## Addendum #2

September 29, 2026

### CIP Project T-57 – SR 169 Pedestrian Bridge

This Addendum, including all attachments and referenced documents, amends the bid documents for the aforementioned project.

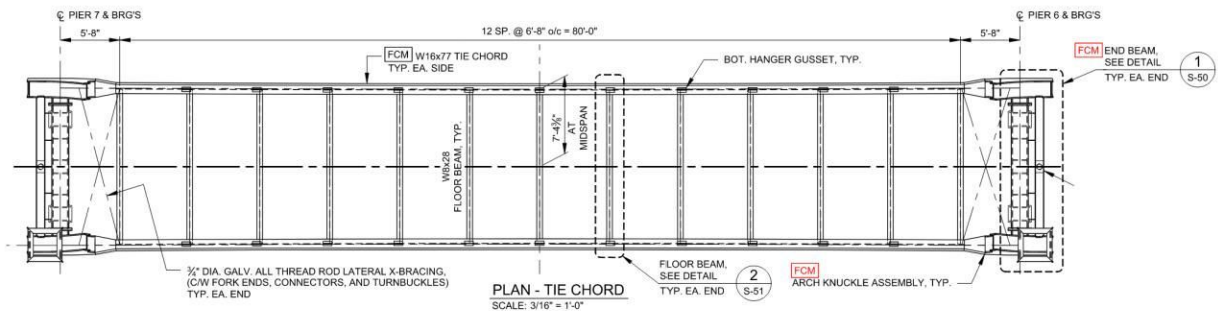
**Q5:** Will bid item A-36 Gravel Borrow Structural Fill be used to backfill stairs where Granular Backfill is required on S-43?

**A5:** Yes, this is correct.
